Inlet Island Maintenance Company

(S Island Dr E, Bonney Lake WA, 98391)

3/21/24

Northwest Play Safe, LLC

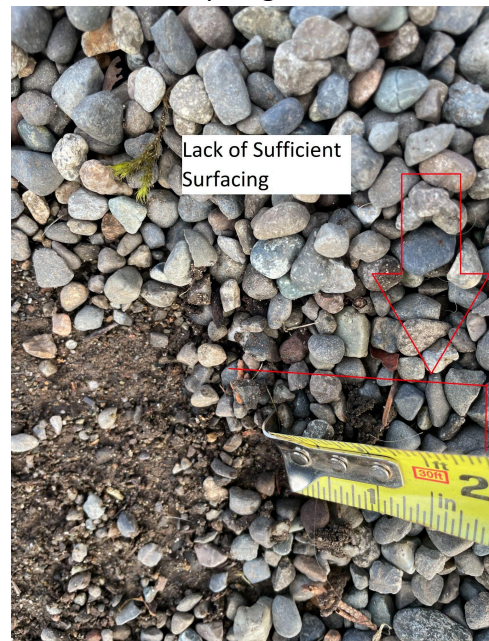
Priority 1 Hazard- Recommendations #1: Head & Neck Entrapment. Contact [Northwest Playground Equipment | Commercial Playground Equipment & Design \(nwplayground.com\)](http://Northwest Playground Equipment | Commercial Playground Equipment & Design (nwplayground.com)) to replace tic-tac-toe panel.

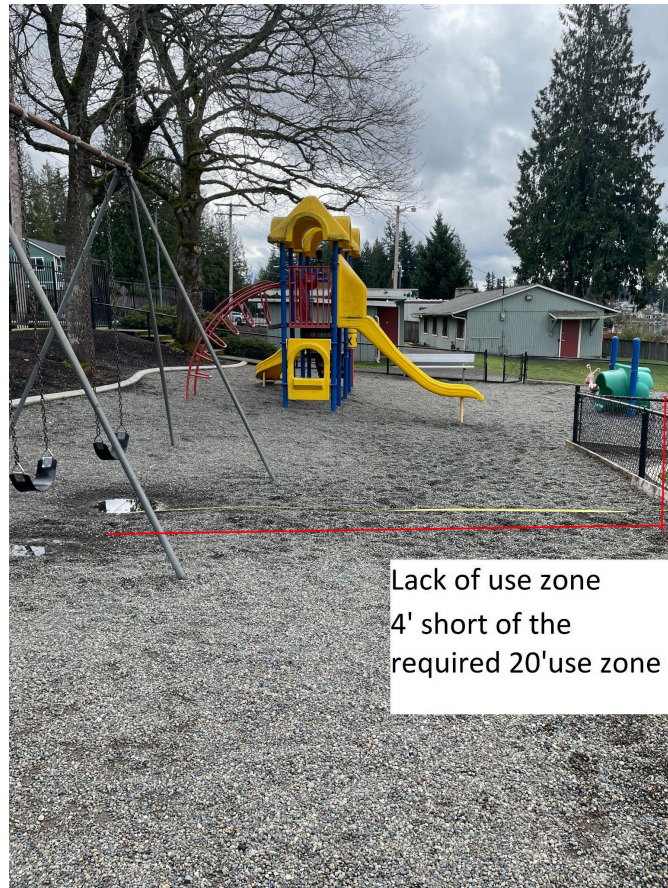
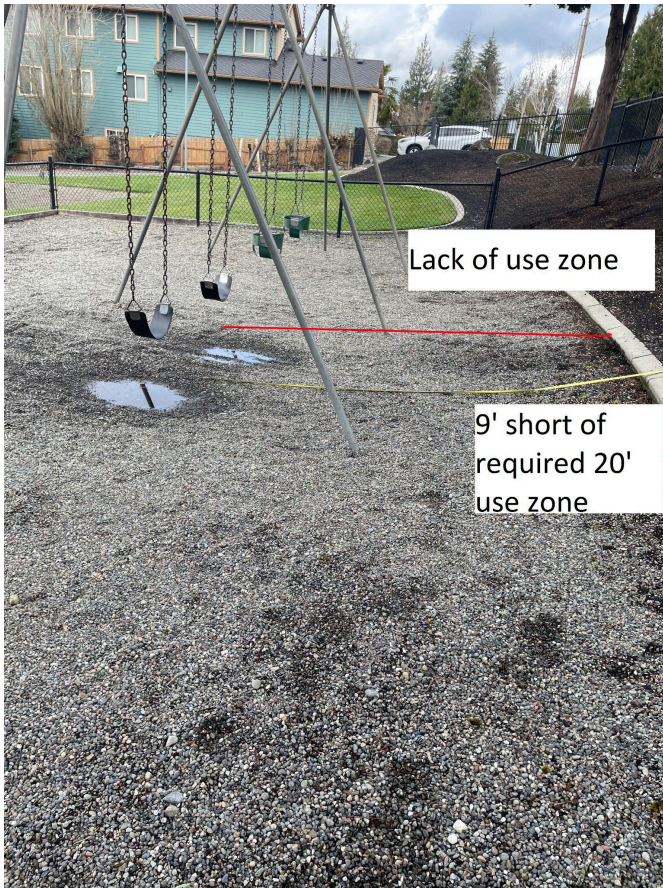
Priority 1 Hazard- Recommendation #2: Severely low safety surfacing. Add additional pea gravel to the entire play area. Add additional 6" of surfacing (pea gravel).
